Access Compliance Report

Public Rights-of-Way

Intersection ID: 52226	Main Street: AMESBURY_HILL_DR	Cross Street: AUBURN_HILL_LN	Location: NE
ADA ID: 7173987F44E4	Ramp Type: Perp	Initial Pass/Fail: Fail	Overall Compliance: No
Codes/Mitigation Info/Possible Solution		Field Measurements/Component Compliance

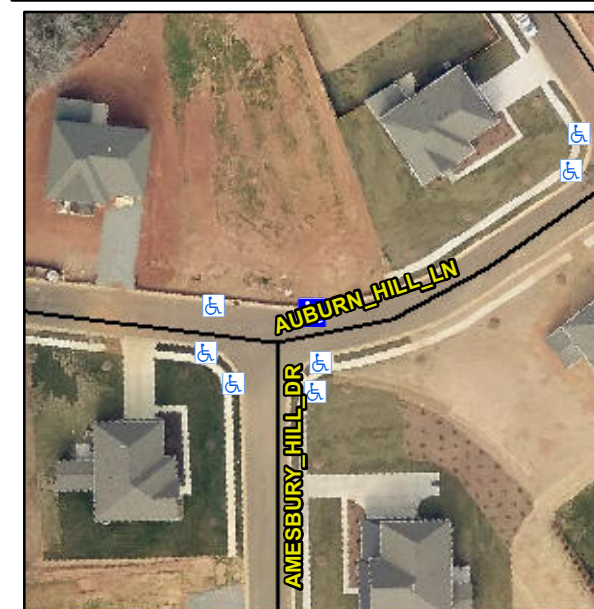
Not Found, R304.5.1, R304.5.3

Compliance	Description	Data	Compliance	Description	Data
N/A	Ramp Length (in)	46.0	Yes	Ramp Slope (%)	6.6
No	Ramp Width (in)	47.0	No	Ramp XSlope (%)	4.3
N/A	Flare Type LT	N/A	N/A	Flare Type RT	N/A
N/A	Flare Slope LT (%)	N/A	N/A	Flare Slope RT (%)	N/A
N/A	Flare Traversable LT?	N/A	N/A	Flare Traversable RT?	N/A
N/A	Landing Length (in)	N/A	N/A	DWS Provided?	N/A
N/A	Landing Width (in)	N/A	N/A	DWS Contrast?	N/A
N/A	Landing Slope (%)	N/A	N/A	DWS Length (in)	N/A
N/A	Landing X Slope (%)	N/A	N/A	DWS Full Width?	N/A
N/A	Landing Curb? (Y/N)	N/A	N/A	DWS Offset (in)	N/A
N/A	Shared Landing?	N/A			
N/A	Gutter Ponding?	N/A	N/A	Gutter Slope (%)	N/A
N/A	Gutter Lip Ht (in)	N/A	N/A	Gutter X Slope (%)	N/A
N/A	Painted X Walk1?	No	N/A	Painted X Walk2?	N/A
	X Walk 1 Direction	To S		X Walk 2 Direction	N/A
N/A	X Walk 1 Width (in)	N/A	N/A	X Walk 2 Width (in)	N/A
	X Walk 1 Slope (%)	2.5		X Walk 2 Slope (%)	N/A
	X Walk 1 X Slope (%)	4.0		X Walk 2 X Slope (%)	N/A

Remove & Replace Entire Ramp.
